Subject: FW: [EXTERNAL] 23316 Harris Arcade - 15 Friar Street

Subject: [EXTERNAL] 23316 Harris Arcade - 15 Friar Street

You asked us to inspect the flank wall of 15 Friar Street and to comment on the condition of the flank wall and attached chimney. We inspected on the 28th August and comment as follows:

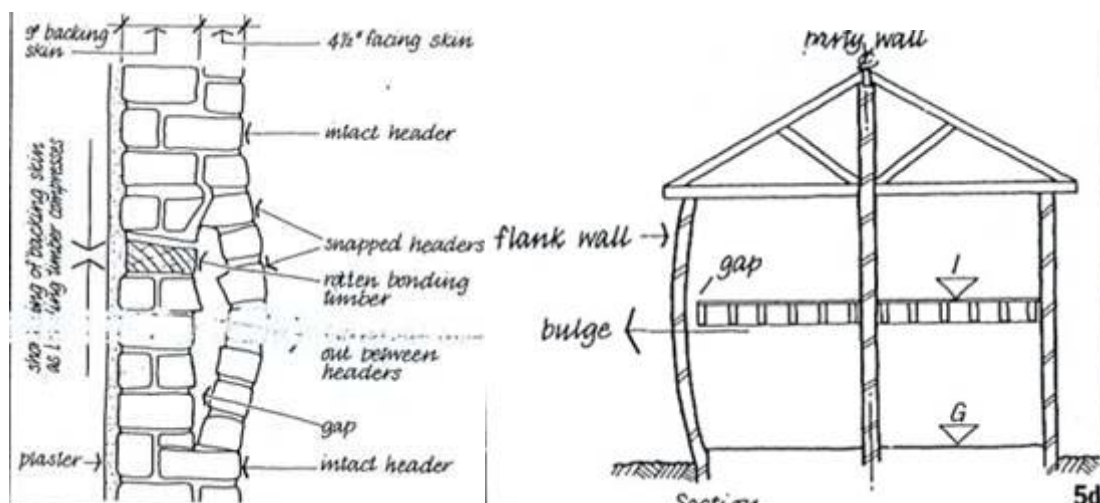
1.1.1 This part of the building is occupied by a dental practice. The flank wall (east side) of the building at second floor and towards the front of the building has suffered from substantial outward movement. The chimney in the flank wall is also leaning. Photos attached.

1.1.2 We believe that there are three mechanisms in play:

- (a) Firstly, there is a localised outward bulge at the level where the roof meets the wall. We believe that this distortion is due to the deterioration of the embedded timber wall plate supporting the roof. Below is a sketch which illustrates this movement, although the sketch shows a gap forming in the wall, which may not be the case here.
- (b) Secondly, a large portion of this wall has bulged out. We believe that this is due to a lack of tie or restraint to the wall. Below is a sketch which illustrates this movement – the gap shown between the wall and the floor may not be present here.
- (c) Thirdly, there is a lean in the chimney.

1.1.3 Sketches illustrating the wall movement:

- 1.1.4 The outward bulge of the wall and lack of tie / restraint may have resulted in the instability of the wall. We recommend that the condition of the timbers and tying provisions are investigated. This is likely to require intrusive investigations internally. The remedial works will depend on the findings of the investigation works. The lack of restraint also means that the chimney is unrestrained over a 2 storey height.
